ADDENDUM NO. 001
NOVEMBER 14, 2025

CITY OF ALBEMARLE, DEPARTMENT OF PUBLIC HOUSING
PROJECT #6276
REPLACE UNDER SLAB – ABOVE SLAB SEWER, KITCHEN / BATH RENOVATIONS
CITY OF ALBEMARLE, NC PROJECT 2026-02
COMM. NO. 6276

Pre-Bid Conference
City of Albemarle, Department of Public Housing
Sewer Line Replacement / Kitchen & Bath Renovations
22 Apartments - #6276
City of Albemarle Bid Number 2026-02

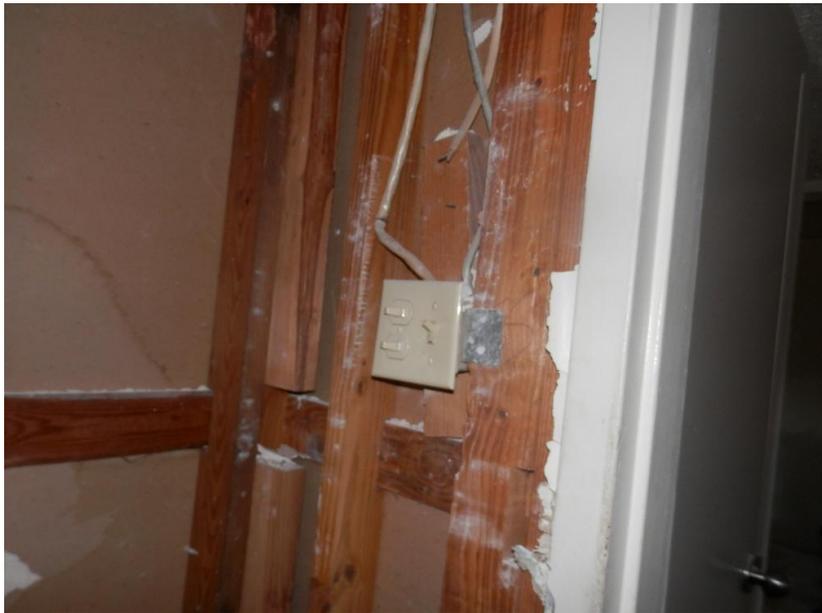
At locations at party wall where sheetrock has been or will be removed, provide 5/8" firerated sheetrock where none exist. This is area under stairs.

Make connections per 2020 NEC
